West Rankin Utility Authority | Administration Building
WBA Project No. 5719

ADDENDUM NO. 02

1 MECHANICAL PLAN - FIRST FLOOR
 E-300 Scale: 1/8" = 1'-0"

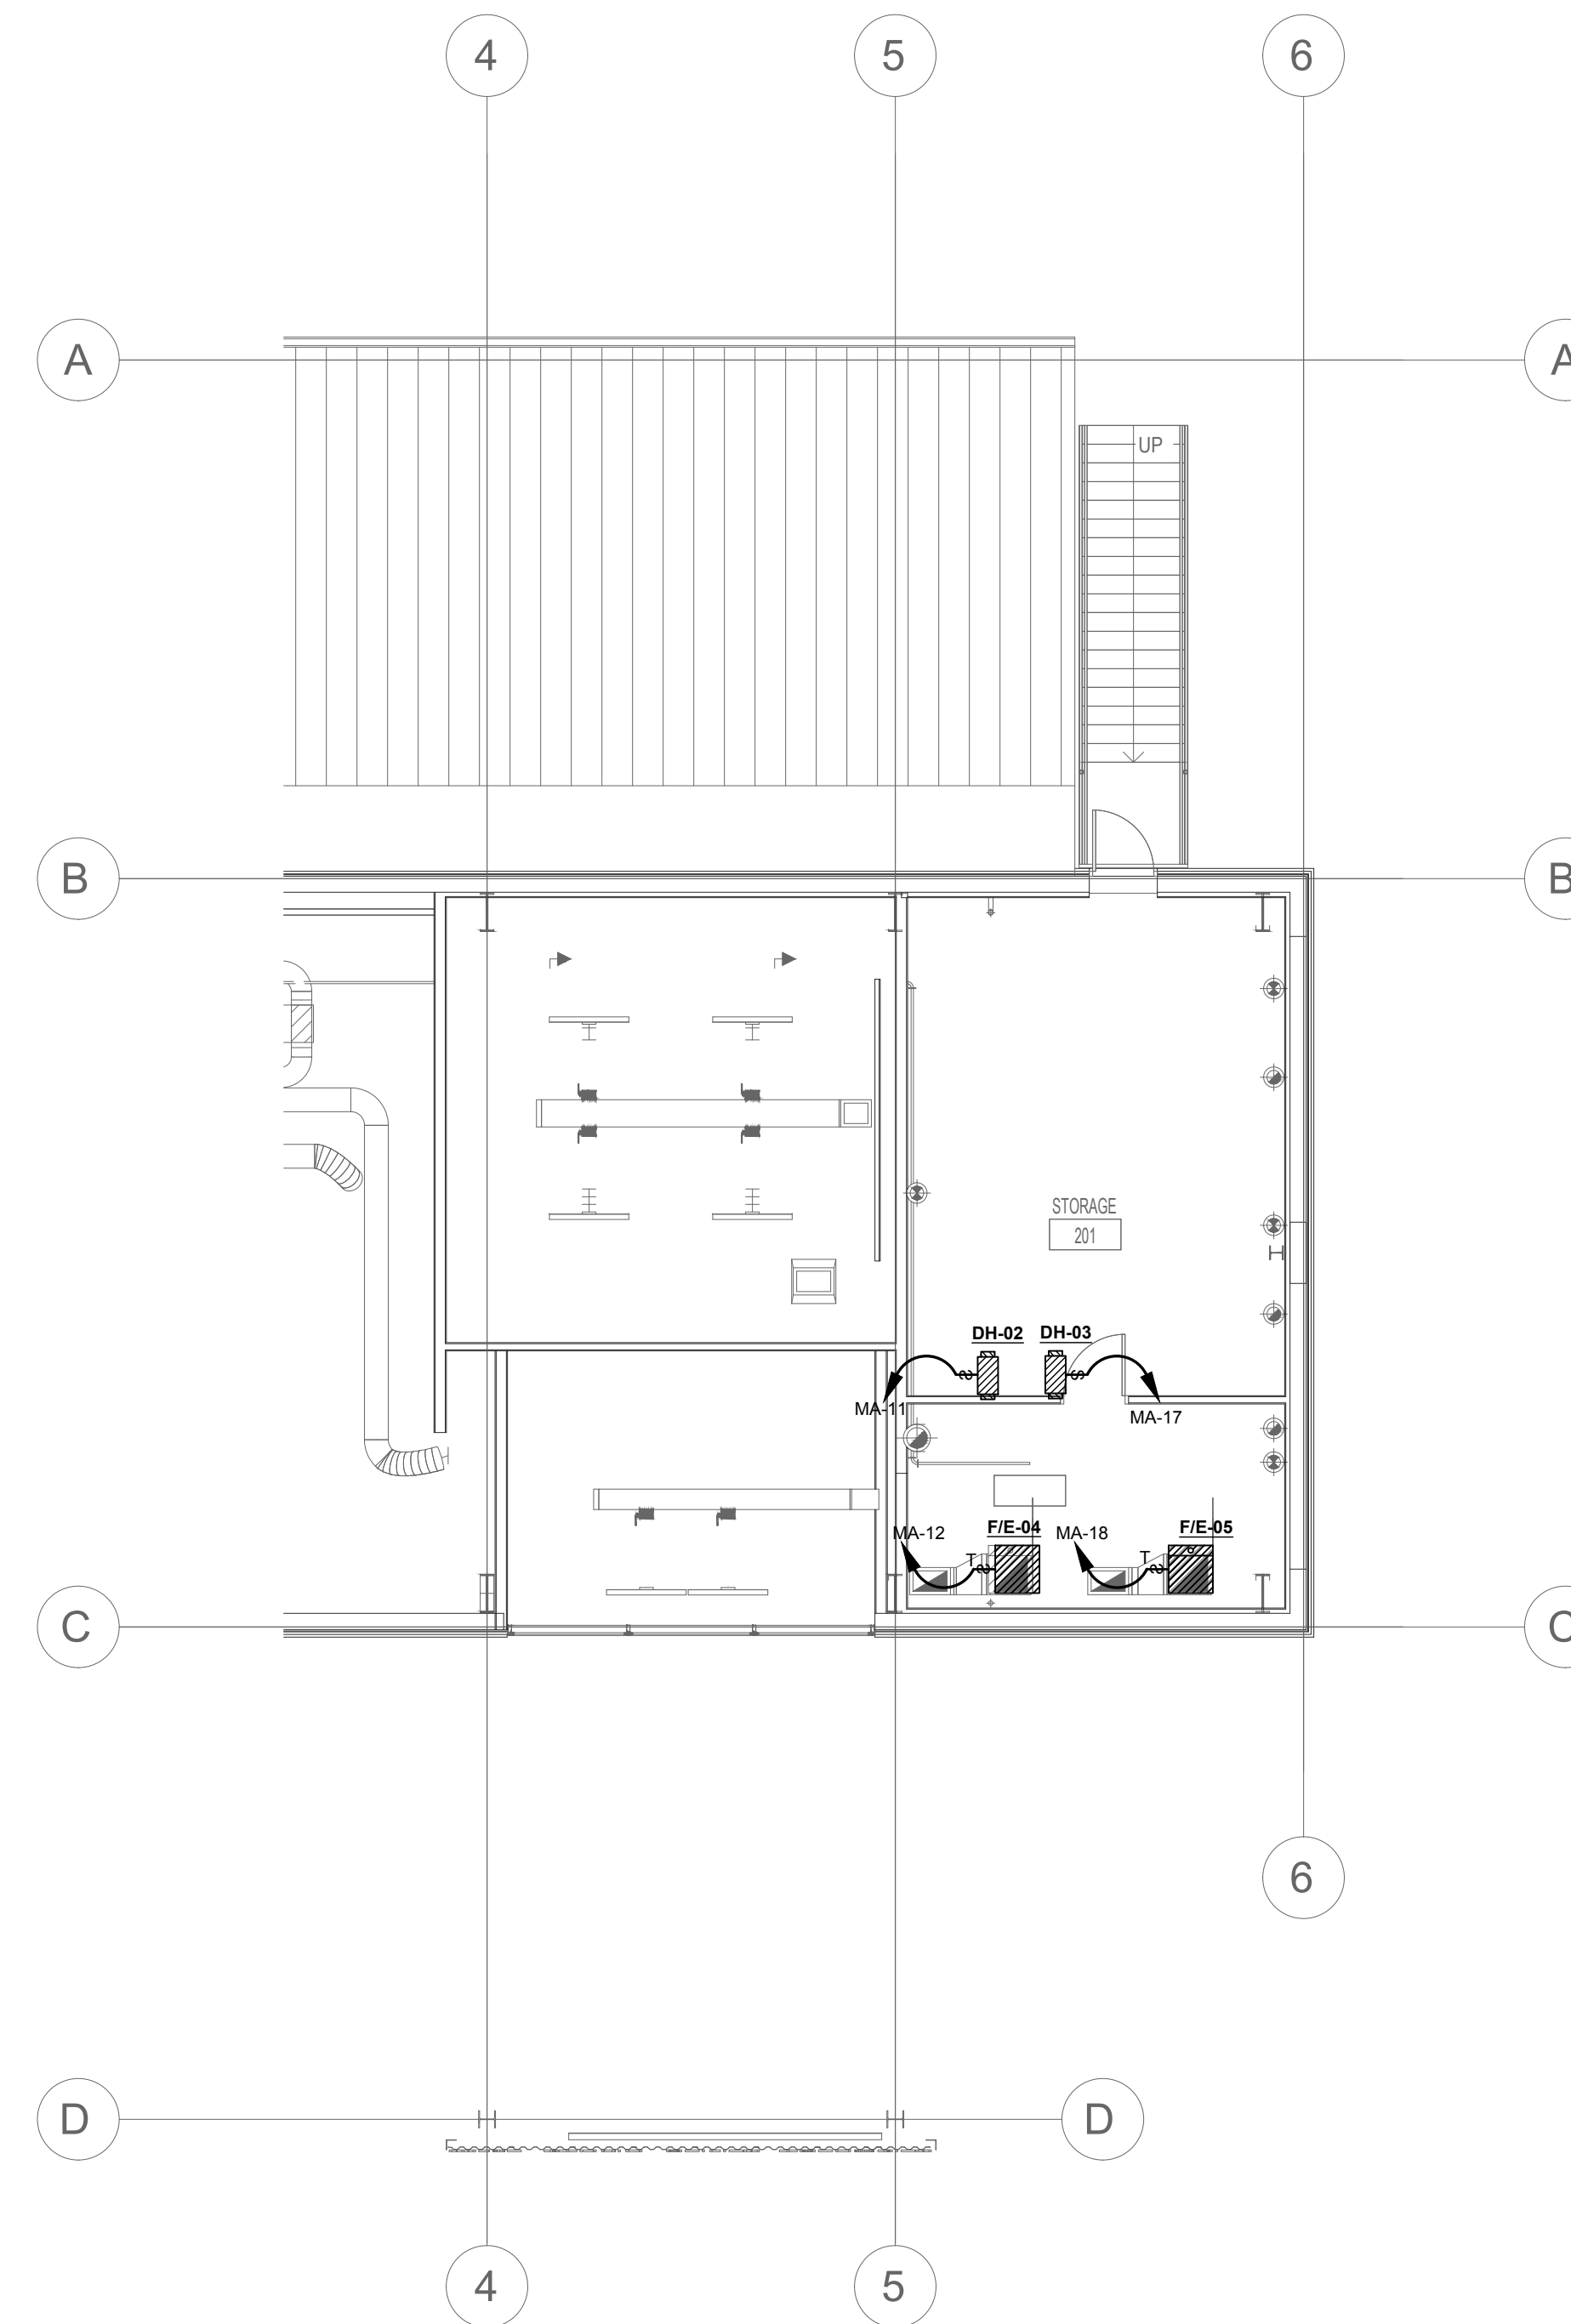
- ITEM NO. 8** **SHEET A701 Interior Elevations**
REVISE sink location in SAMPLES 119
DELETE under cabinet lighting in Break Room 112
- ITEM No. 9** **SHEET M101 HVAC New Work Plan**
DELETE sheet in its entirety and **REPLACE** with attached sheet. Revised to add specific notes in the upper right-hand corner. Revised Exhaust Fan labeling to match Fan Schedule. Revised to remove humidistat in Rooms "SAMPLES 119" AND "HALL 114".
- ITEM NO. 10** **SHEET E001 Panel Schedule**
ADD Circuit for WH-01 to Panel MA
- ITEM NO. 11** **SHEET E301 Mechanical Plan**
ADD Circuit for WH-01
